Project No. 05704-52-54A
October 22, 2019

Subject: RESPONSE TO CITY REVIEW COMMENTS
MEADOWS DEL MAR (THE BOUGAINVILLEA)
LOT 80: 5702 MEADOWS DEL MAR
PTS# 604841 – MEADOWS DEL MAR SDP
SAN DIEGO, CALIFORNIA

In accordance with the request of the request of Mr. Nick Psychogios with Latitude 33, we prepared this letter to respond to City of San Diego review comments (Reference 1). The review comments specific to geotechnical engineering aspects are provided herein followed by our responses.

SCALE 1" = 60'	DATE 10 - 22 - 2019
PROJECT NO. 05704 - 52 - 54A	FIGURE 1
SHEET 1 OF 1

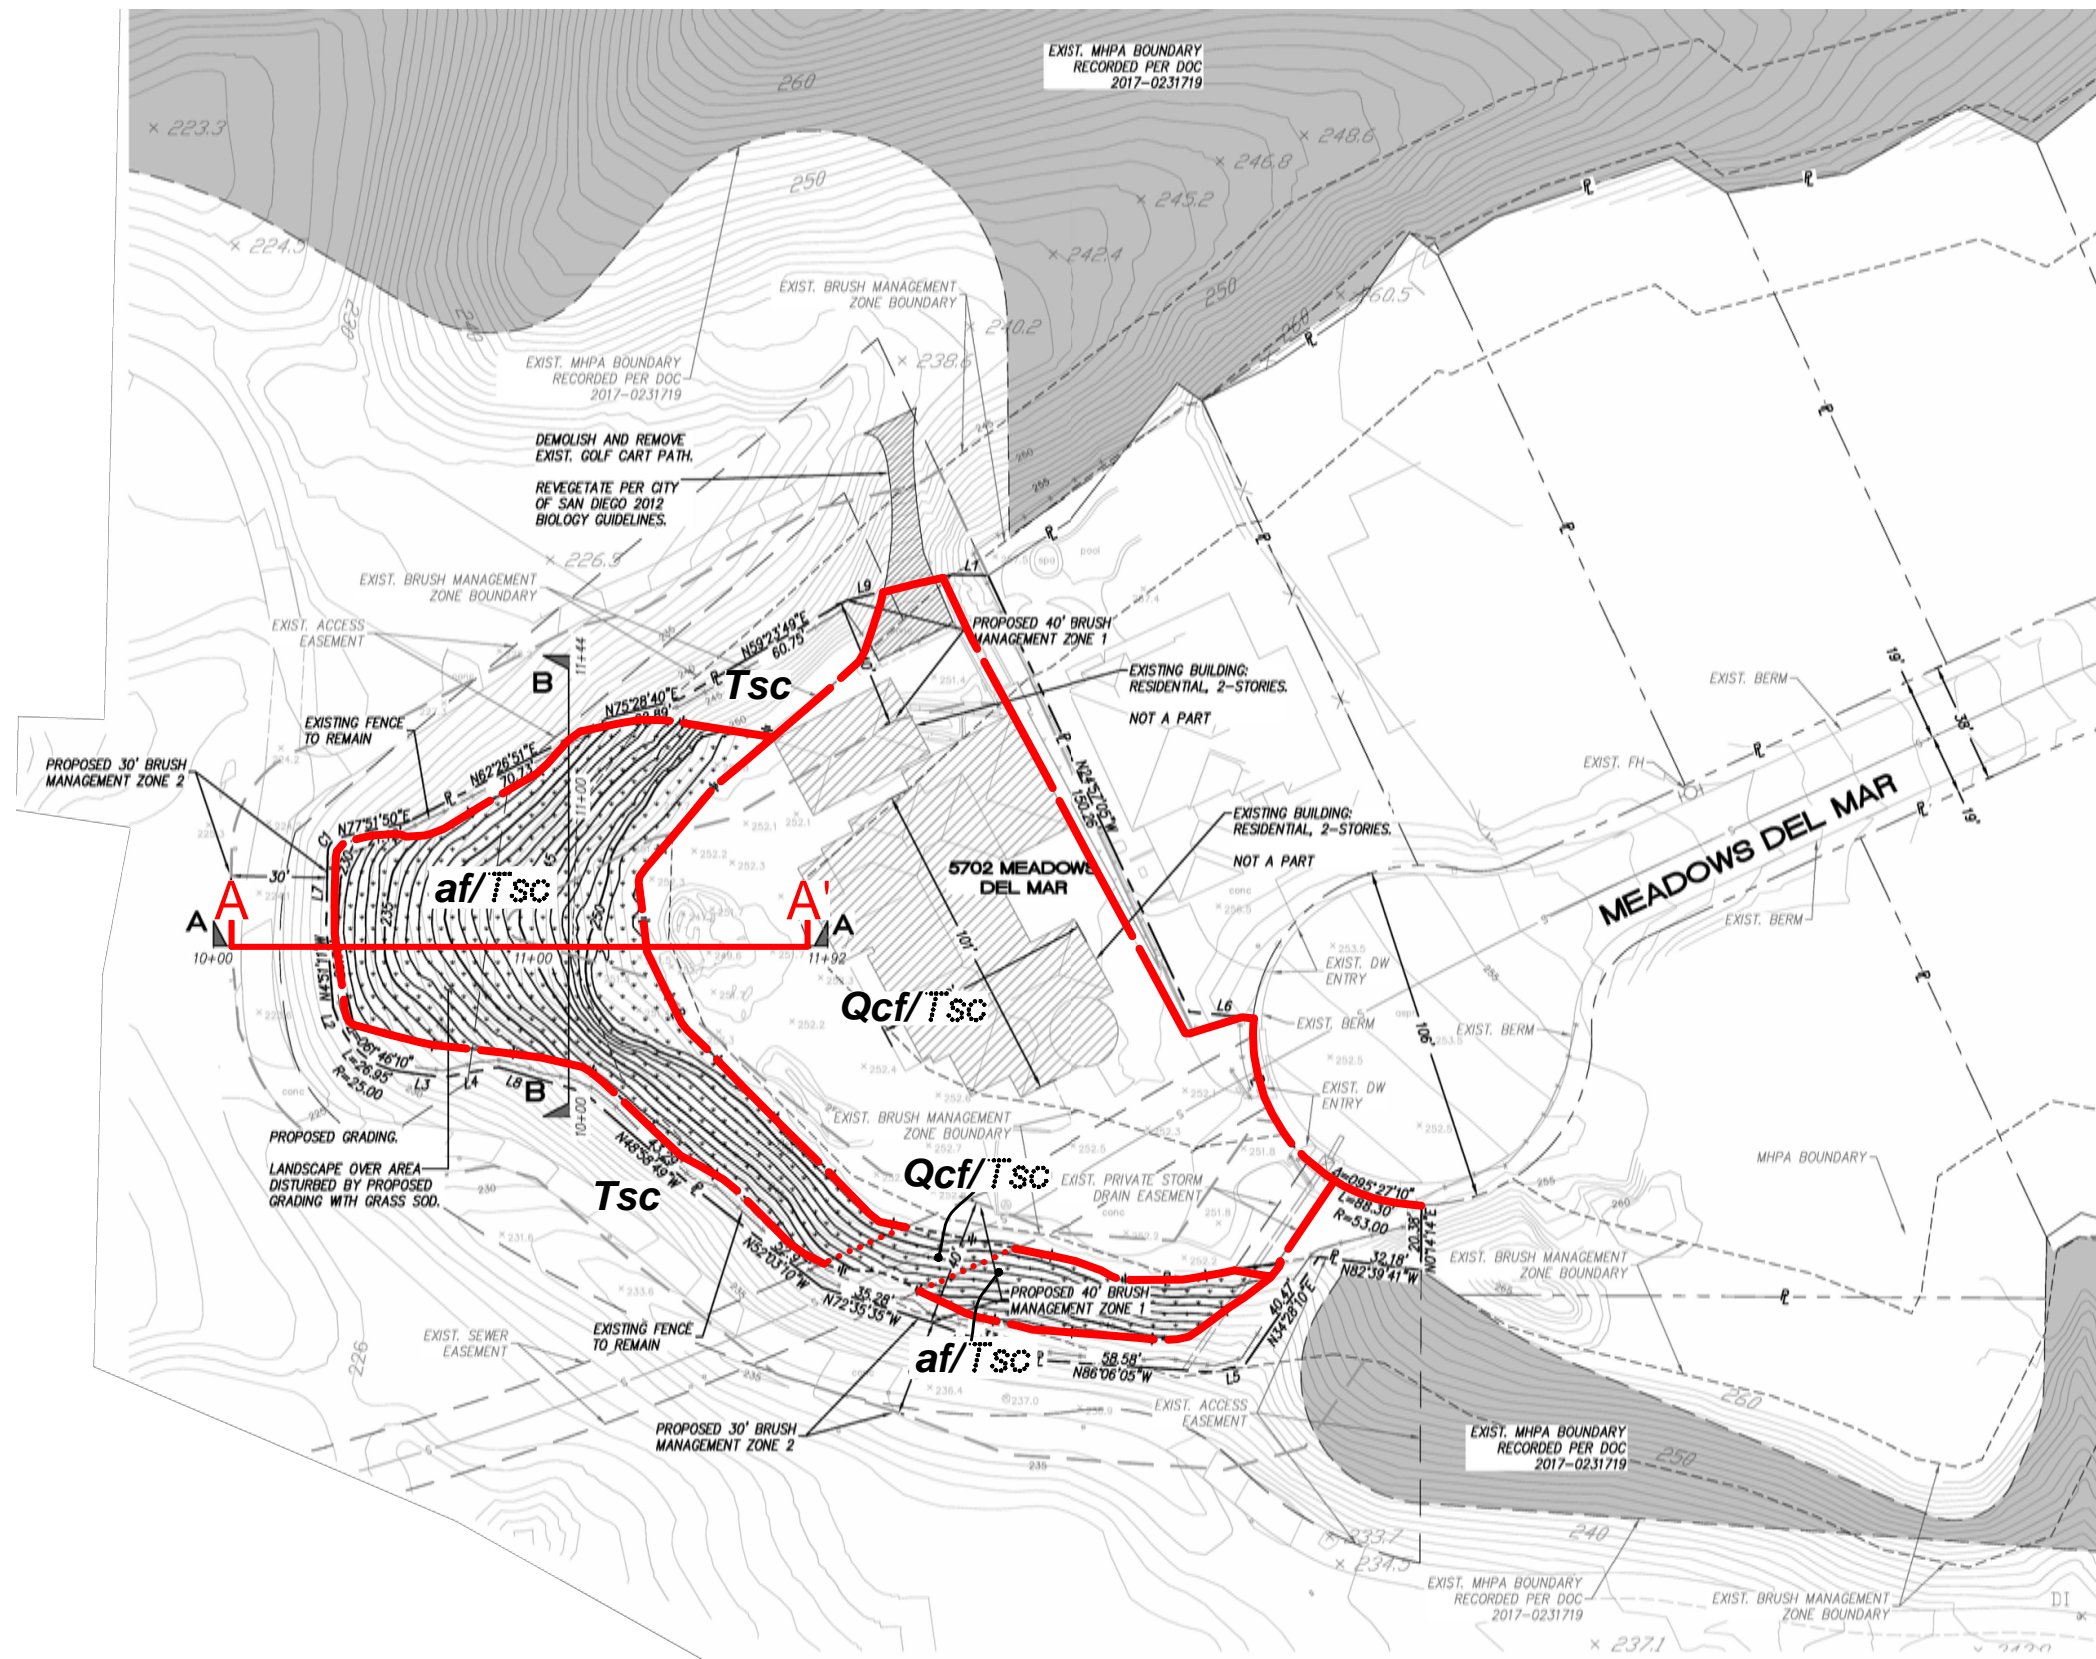
Comment No. 6: *Provide an updated, site-specific geologic map that depicts the current geologic conditions, existing and proposed development. Circumscribe the recommended limits of remedial grading (if applicable).*

Response: Figure 1 presents a site-specific Geologic Map depicting the current geologic conditions and additional grading subsequent to the referenced report dated November 13, 2009. The additional grading has been completed.

GEOLOGIC CROSS-SECTION A-A'

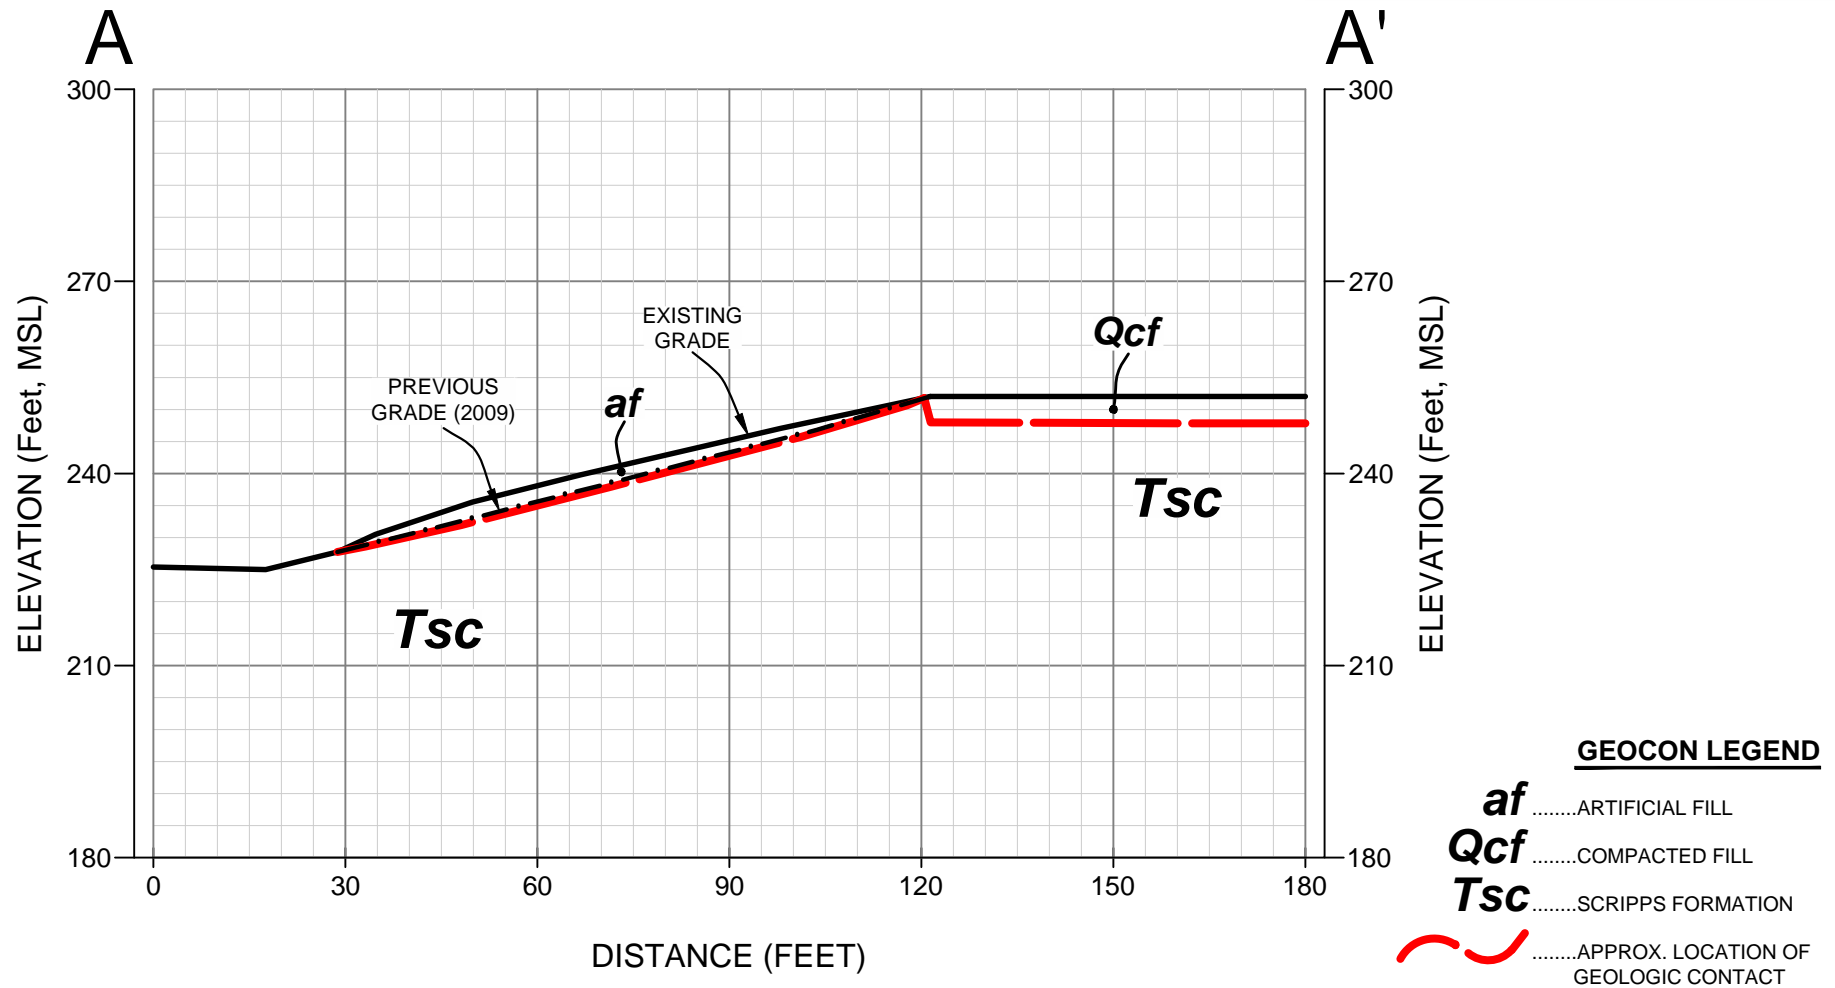
Comment No. 7: *Provide representative geologic/geotechnical cross section that shows the existing and proposed grades, distribution of fill and geologic units.*

Response: Figure 2 presents a Geologic Cross-Section presenting the existing and proposed grades, and distribution of fill and geologic units.
